**SITE PLAN REVIEW 2025-014
200 Casentini Street**

Date: 9/25/2025
Application: SPR2025-014
Address: 200 CASENTINI ST
Scope: 88 affordable multi-family units
Contact: Contact
Planner: Son Pham

PURPOSE: CUP2025-025, SPR2025-014 & PUD2025-003 **DATE:** 3/18/2026
LOCATION: 200 Casentini St **PLANNER:** Son Pham
APPLICANT: Milestone Housing Group **REVIEWER:** Fernando Rizo, QSD
ENGINEER: BKF Engineers Assistant Engineer

Date:	March 10, 2026
Project Number	PUD2025-003, SPR2025-014 & CUP2025-025
Owner Name	INTERIM, INC. Monterey County Housing Authority
Applicant Name	Milestone Housing Group
Address	200 Casentini Street
Project Description	AMENDMENT TO A PLANNED UNIT DEVELOPMENT PERMIT (PUD 92-006) - PUD 2025-003; A REQUEST TO CONSTRUCT 88 AFFORDABLE MULTI-FAMILY HOUSING UNITS (SPR 2025-014) WITH A DAY CARE CENTER (CUP 2025-025) LOCATED AT 200 CASENTINI STREET IN THE RESIDENTIAL HIGH DENSITY (R-H-2.1) ZONING DISTRICT
Plan Review Sequence	1 st Review - SPR2025-014 & CUP2025-025 2 nd Review - PUD2025-003 3 rd Review - PUD2025-003, SPR2025-014 & CUP2025-025 4 th Review - PUD2025-003, SPR2025-014 & CUP2025-025
<i>Plans for the above-referenced project have been reviewed. Revisions are re

SITE PLAN

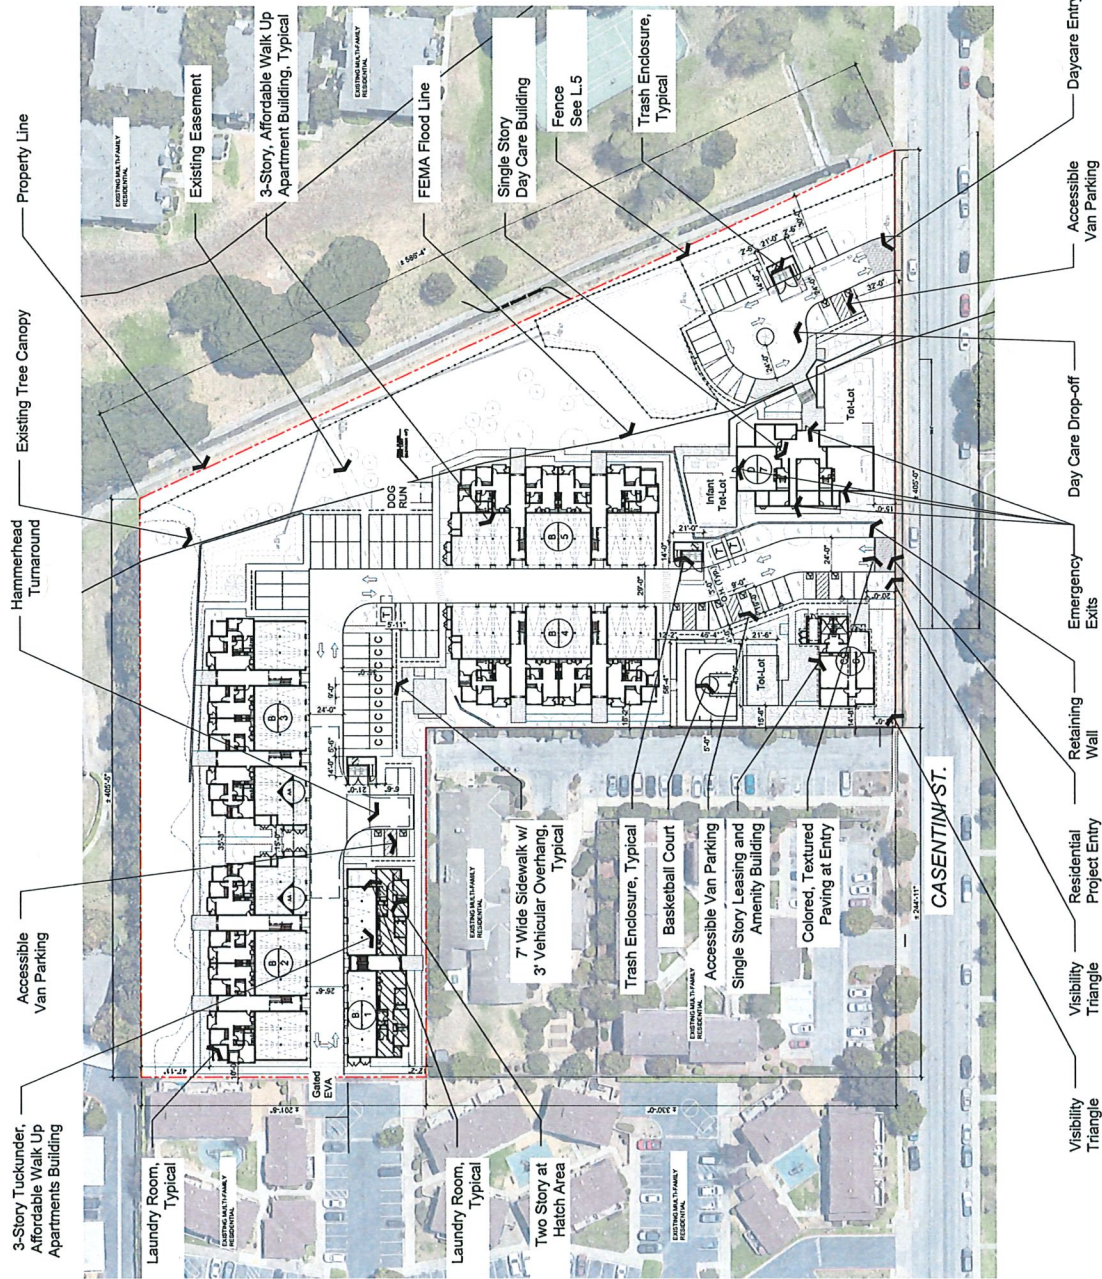
5. Site Plan – Access shall be maintained to existing City of Salinas Drainage Easement. Existing slope and sidewalk easements may be abandoned.
6. Site Plan - Proposed trash enclosure shall conform with City of Salinas 57A. Provide 2' minimum landscape strip, 2" weep holes, and concrete pad drainage patterns flowing towards required weep holes and landscaping strip.

EVA GATE

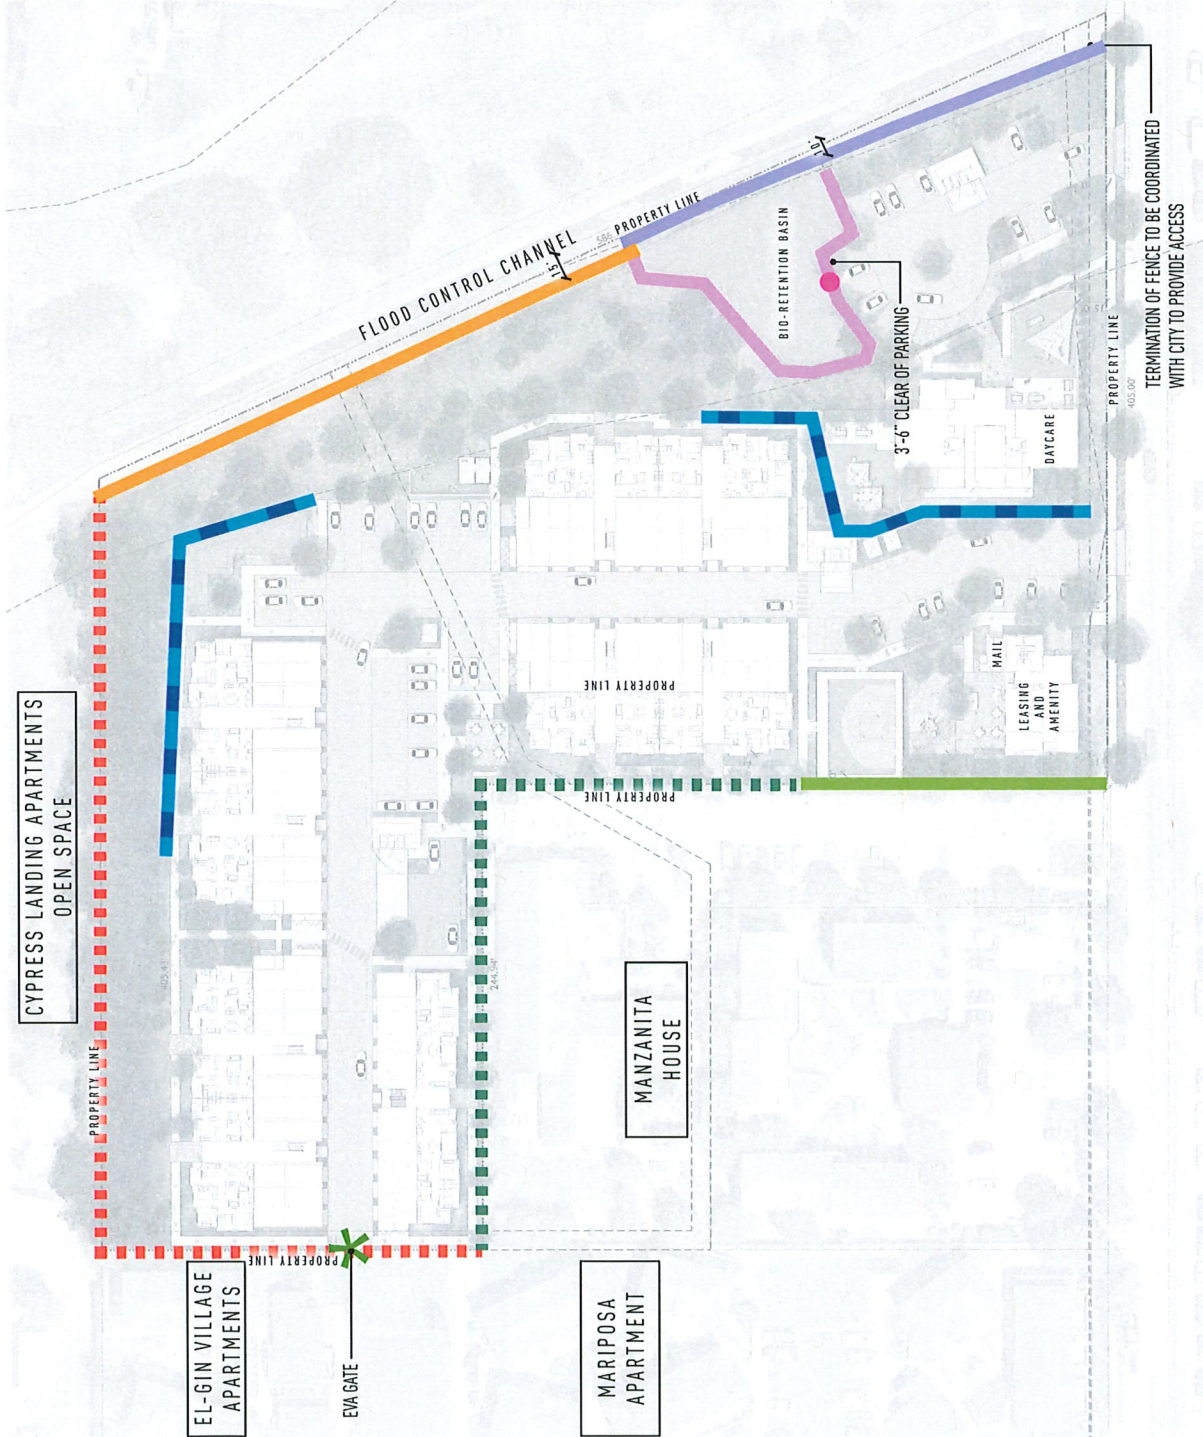
13. Emergency Access Gate – Add the following note to the plan:

RESPONSE REQUIRED: At the time of building permit submittal, Print this note on the plans.
